LAND PROTECTION DIVISION  
DEPT. OF ENVIRON. QLT  
Project No: 20-12-30

**Re: ODEQ Notice of Deficiency Letter Dated December 17, 2020, Tier III Permit Modification, Creek County C&D Landfill; ODEQ Permit 3519020; Creek County**

**ATTACHMENT 1**  
**REVISED DRAWING 5**

DRAWING 5

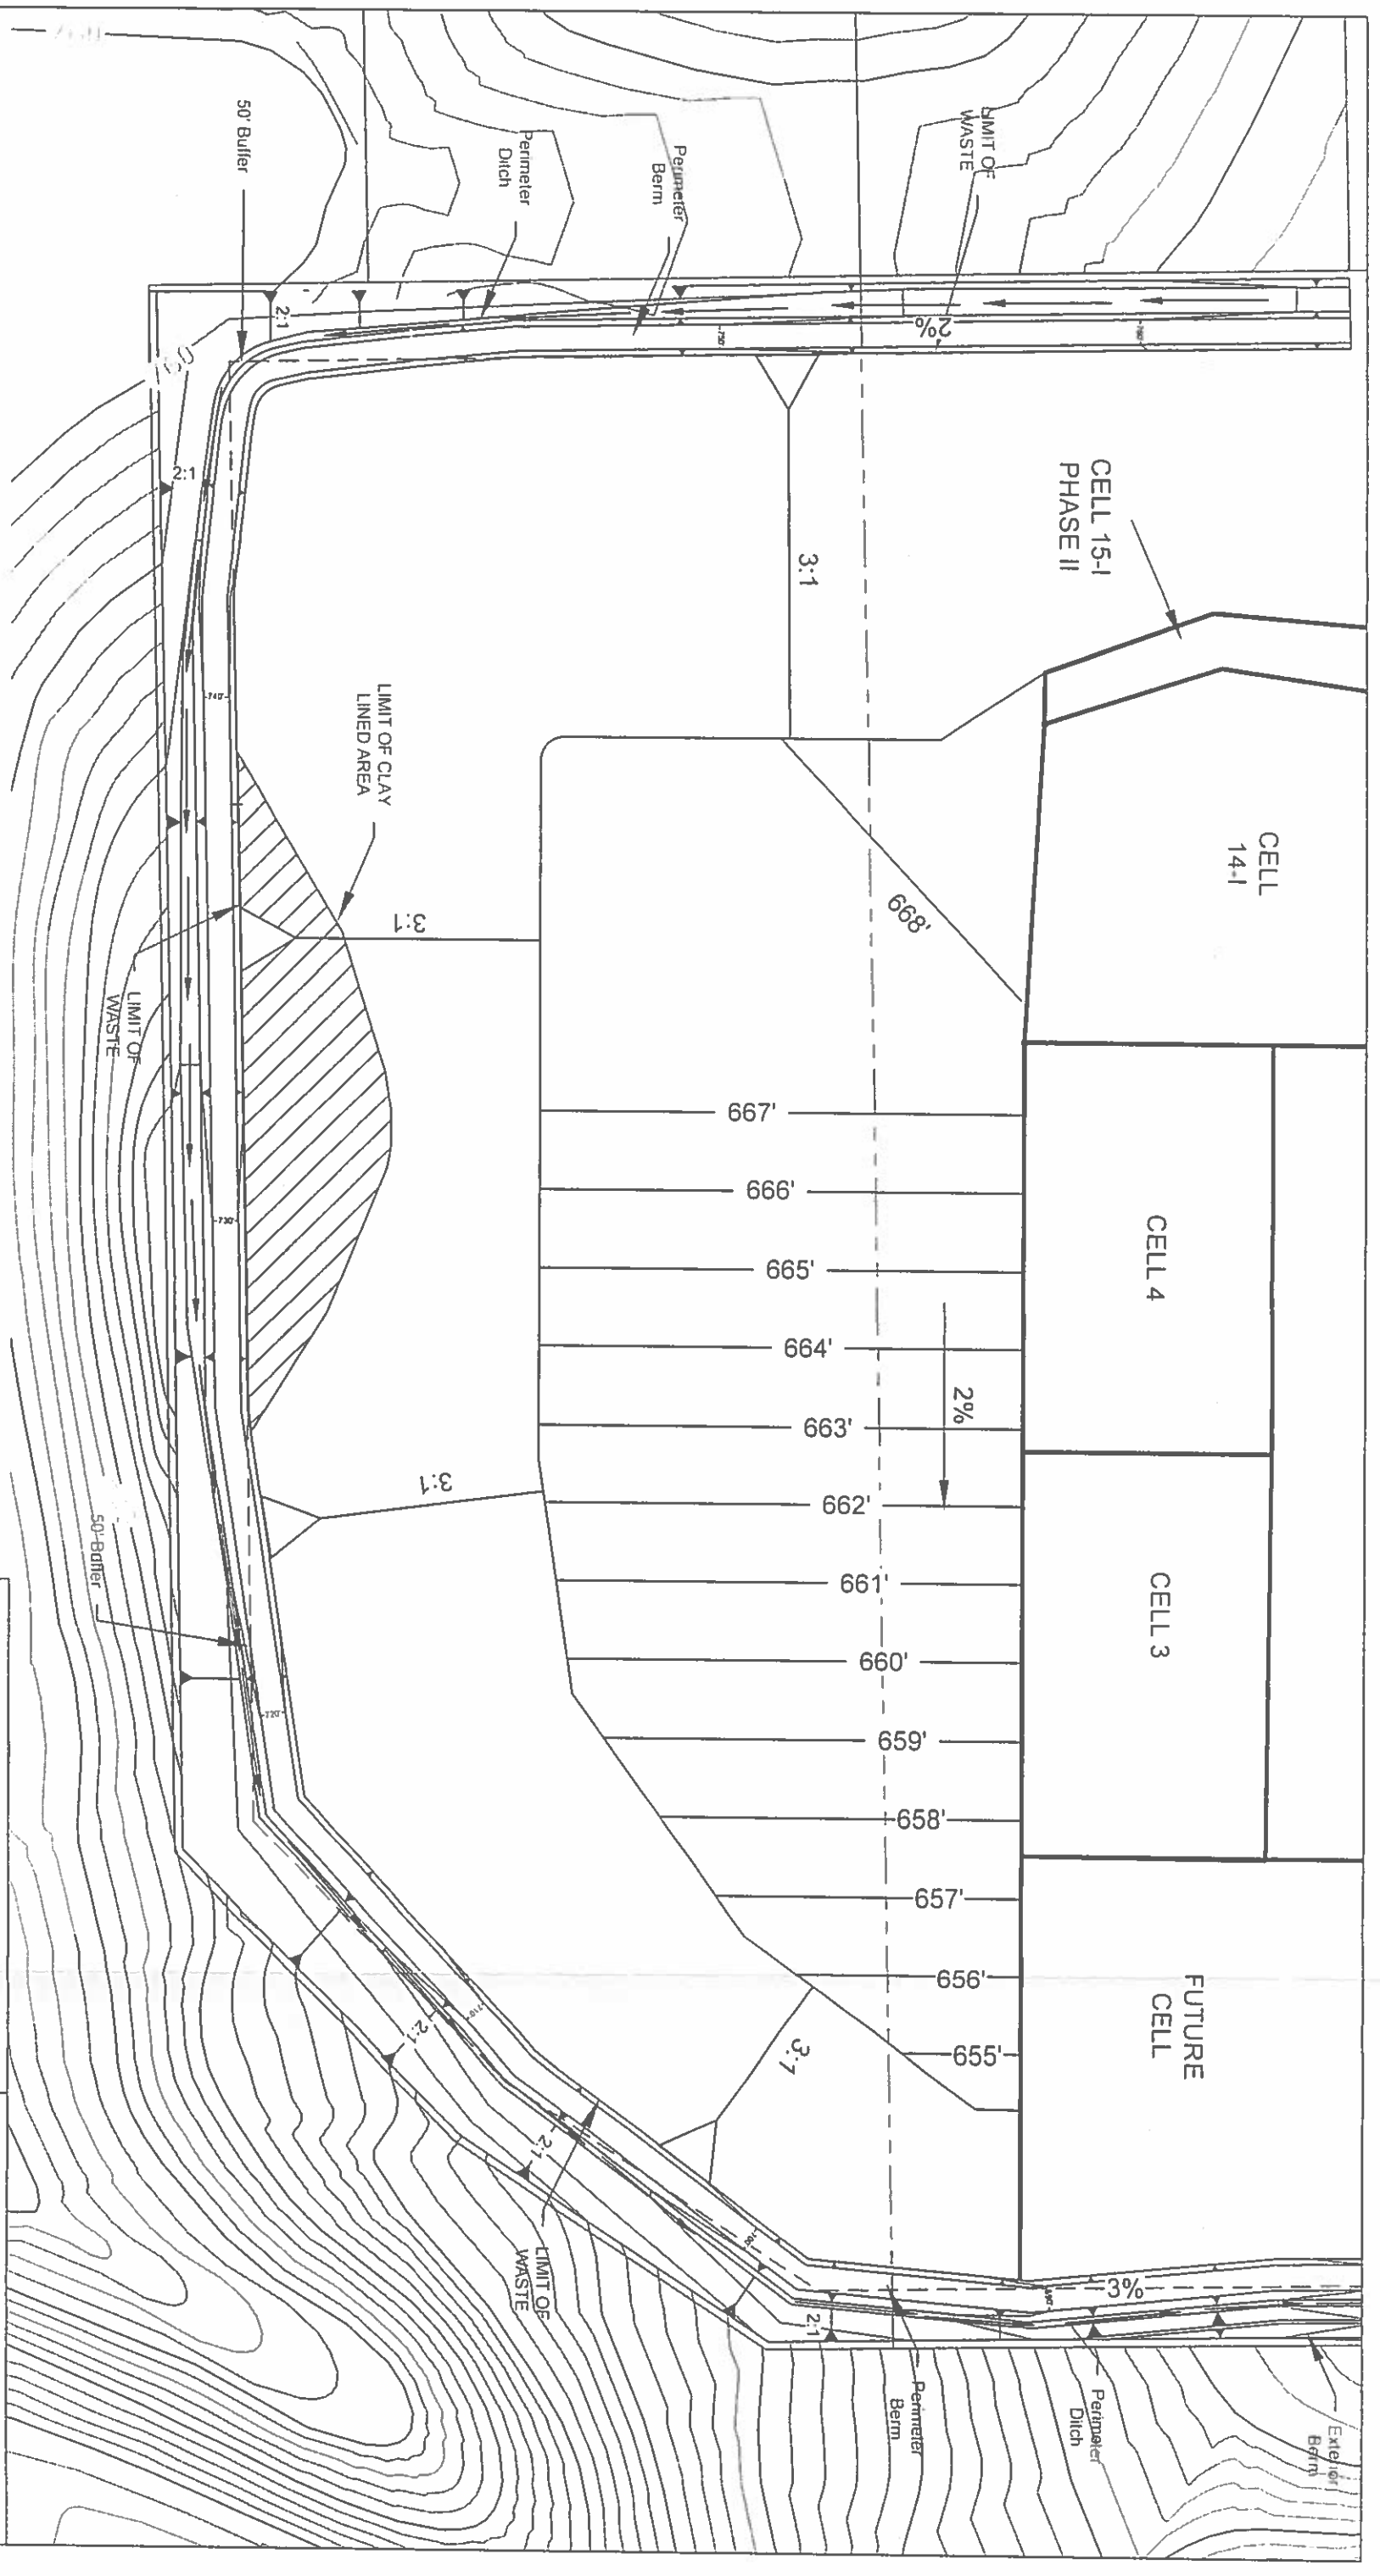
**Comment 1.:** *The Application states the new cell will be constructed with a hybrid liner, consisting of recompacted clay and in-situ liner in different portions of the expansion area. No details of construction or design drawing were included in the Application for review of this liner system. Please update the Application to include this information, including relevant design drawing in accordance with OAC 252:515-3-57.*

**Comment 2.:** *The Application references a Drawing 5C as showing the in-situ and recompacted clay portions of the liner. This Drawing was not included in the Application submitted.*

**Response:** A small portion of the western slope of the expansion area will require earth fill. This portion of the cell will be lined with a three foot thick clay liner. The remainder of the expansion area is intended to be lined with an in-situ liner. Drawing 5 has been revised to illustrate the limits of the clay liner. A note has also been added to Drawing 5 indicating that the remainder of the expansion area is anticipated to be lined by and in-situ liner. Details for the clay liner and in-situ liner are provided on Drawing 8. A revised version of Drawing 5 is provided in Attachment 1.

**Response:** The references to Drawing 5C on pages 23 and 24 of the application are typographical errors. The correct reference is Drawing 5. Replacement pages with the correct reference is provided in Attachment 2.

- 1 Survey information provided by Pennco Engineering & Surveying
- 2 Topography provided by U.S. Geological Survey, National Geospatial Technical Operations Center, 2012
- 3 An in situ liner is anticipated for the entire expansion area except for the small area to be lined with a 3 foot thick clay liner depicted

**CREEK COUNTY LANDFILL**  
**GAMMA - NEUTRON api**  
**PZ14-3**

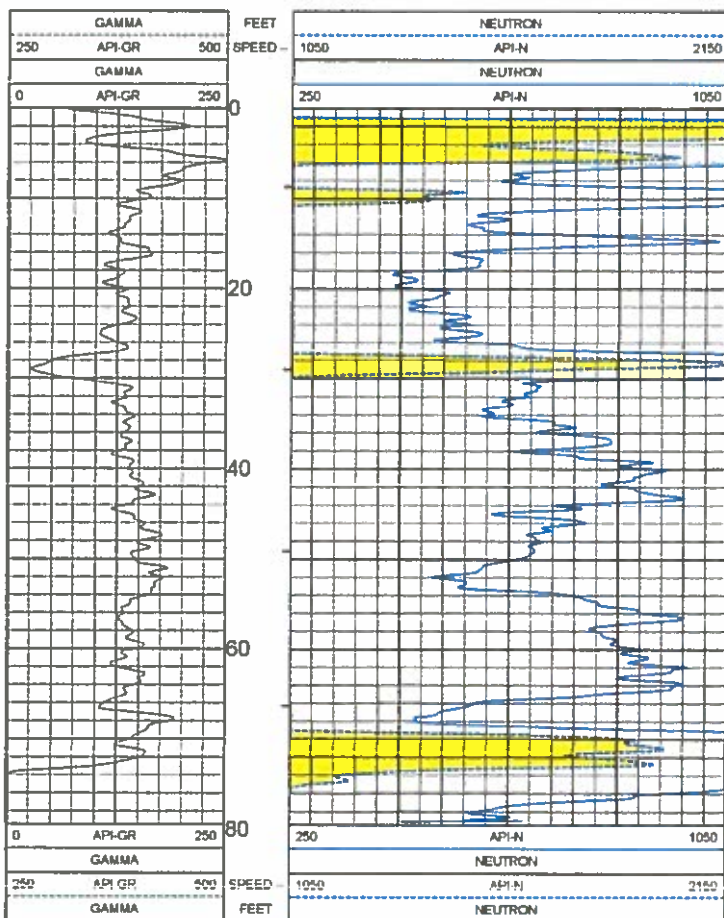
Comment 4.: *The approved drilling plan specified three (3) borings would be logged by geophysical means and the results submitted with Tier III application. Review of the Application found no logs from the borings made within the area of expansion. Please update the Application to include these logs.*

Response: Piezometers BPZ14-1, BPZ14-3 and BPZ14-5 have been logged using gamma ray and neutron geophysical tools per OAC 252:515-7-34(c)(1). Copies of the logs are provided in Attachment 3.
